Subject: AP1000 Response to Request for Additional Information (SRP 12)

RAI-SRP12.3-CHPB-02 R1

AP1000 TECHNICAL REPORT REVIEW

RAI Response Number: RAI-SRP12.3-CHPB-02

Figure 1.1 - Dimensions Associated with AP1000 Fuel Handling

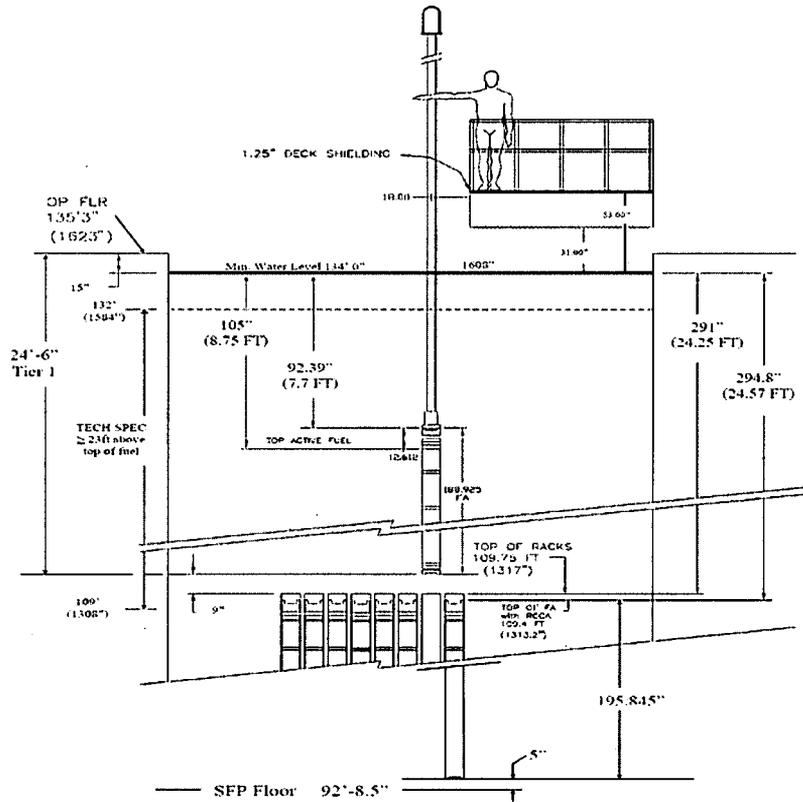
Provide a complete description of the potential radiological effects and dose estimates associated with the reduction of the minimum water level over active fuel in the refueling and spent fuel pool. Include this information in the DCD and provide a markup in your response.

1. Provide clarification relative to why dose evaluations were performed at two water coverage elevations, 102" and 105" above the active portion of the fuel.
2. Provide clarification relative to why Case D sources (based on once-burned fuel assemblies) are the most conservative source terms; particularly since the total gamma source associated with Case A (core average power per assembly) exceeds that of Case D.
3. Provide more information related to the ALARA controls that are used to lower dose during refueling. This should include a brief discussion on controls used to limit dose for failed fuel.

As shown in Figure 1.1 below, the current configuration of the SFP, fuel handling elevation, and FHM is illustrated. The minimum water coverage over active fuel during fuel handling operations is 105". The FHM operating deck where the operator stands on is approximately 53 inches above the SFP water surface (based on a minimum SFP water elevation of 134'-0"). The FHM deck thickness is 1.25" thick. This current configuration limits exposure rates to personnel on the FHM to 2.5 mR/hr or less. The configuration of the Containment Building Refueling Machine (RM) is bounded by the FHM since the RM has shielding from the mast structure and more distance from the fuel assembly to the operator.
